SUNDRY NOTICES AND REPORTS ON WELLS

AXI Apache H

Title Proposed P&A Sketch
AXI Apache H #6

CONDITIONS OF APPROVAL

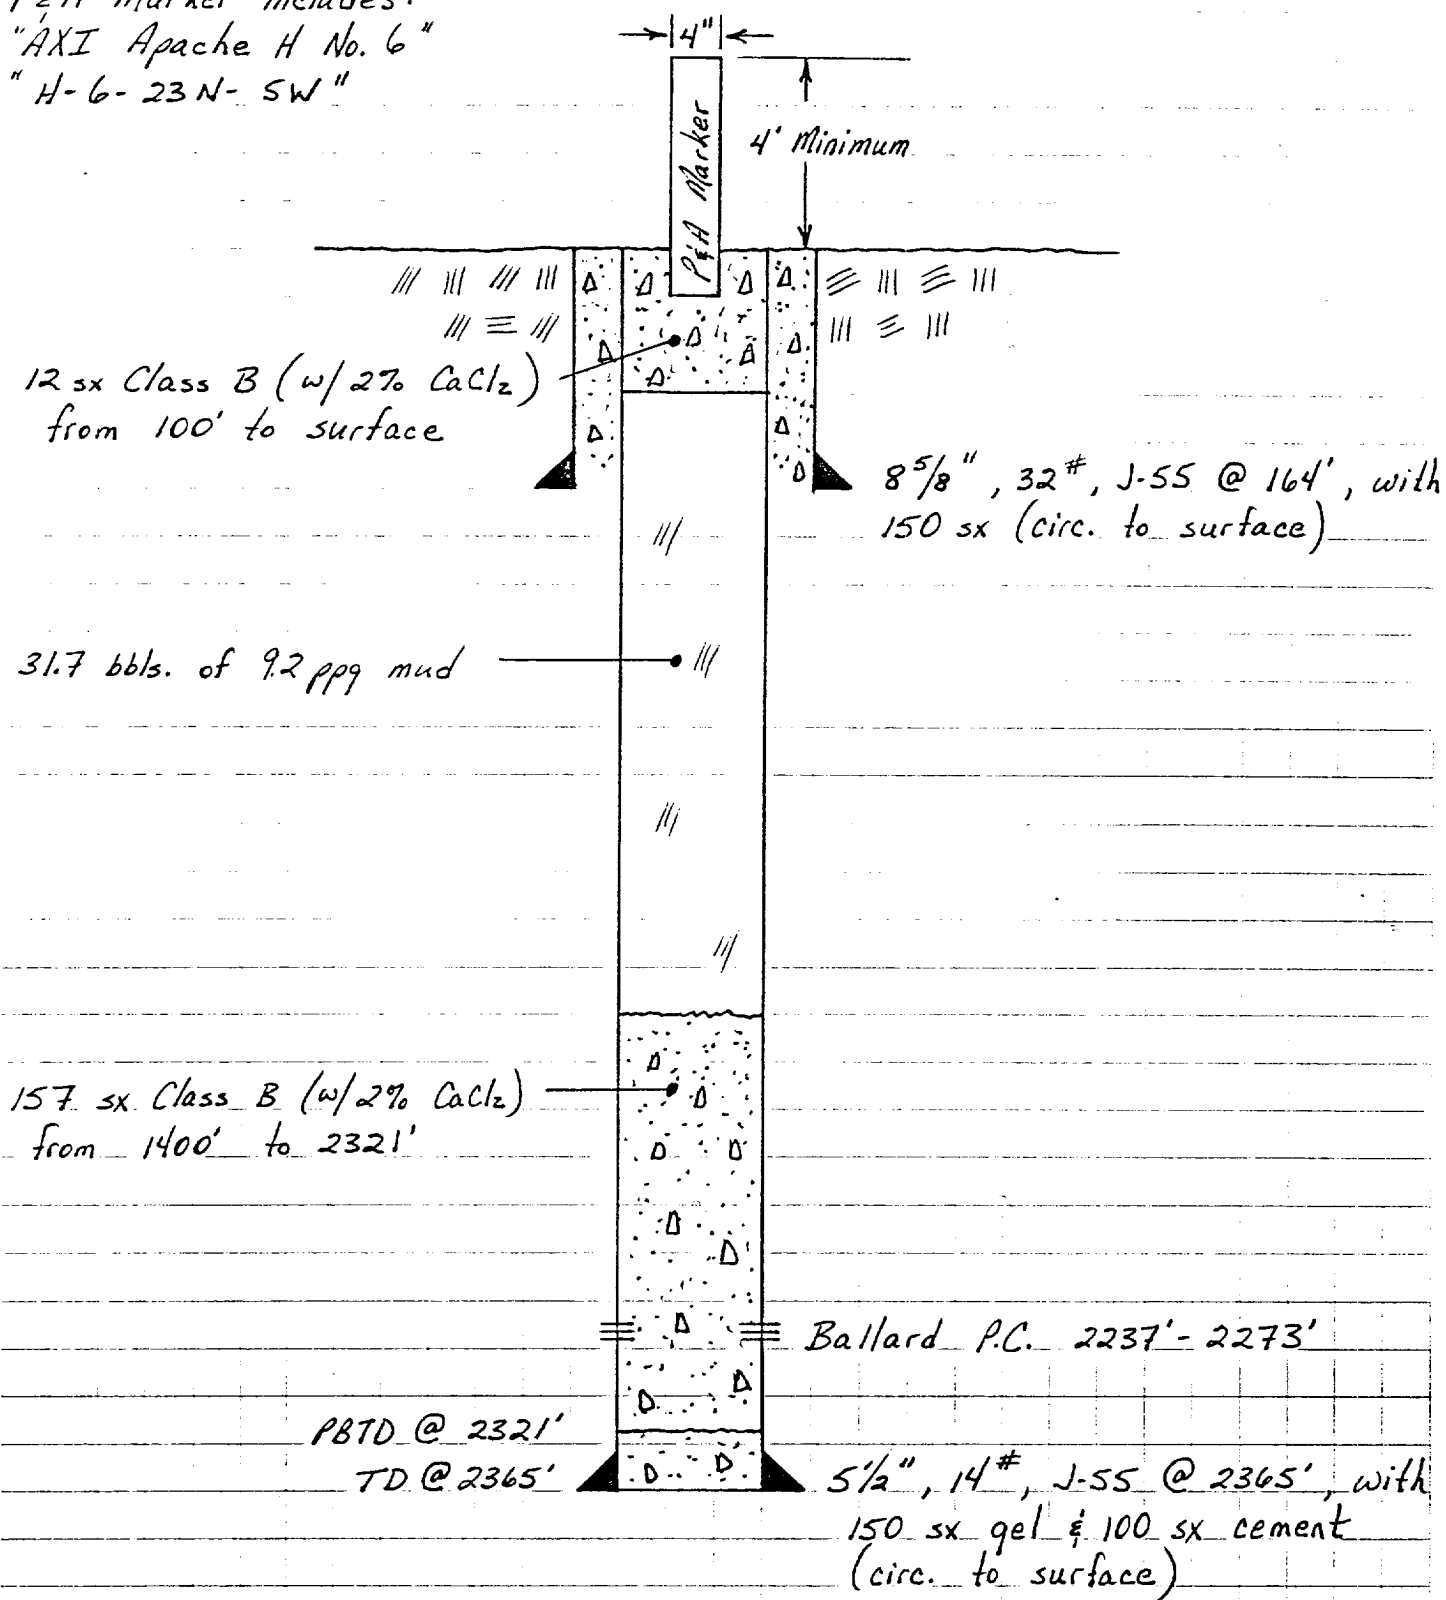
- ① MIRU, Pull tbg
- ② Bullhead 157 sxs class "B" w/2% CaCl₂ followed by 31.7 bbls 9.2 ppg mud followed by 12 sx class B w/2% CaCl₂ down 5 1/2" csg.
- ③ This sequence of cmt & mud will sqz 50 sxs into perfs, leave a cmt plug @ 1400' & a 100' surface plug.
- ④ Cutoff csg. a minimum of 3' below final restored ground level & install P & A marker.
- ⑤ Clean location & rig down
- ⑥ A proposed P & A sketch is attached.

P&A Marker includes:
 "AXI Apache H No. 6"
 "H-6-23N-SW"

APPROVED
8-11-86

AS AMENDED

5. The following modifications to your plugging program are to be made (when applicable):
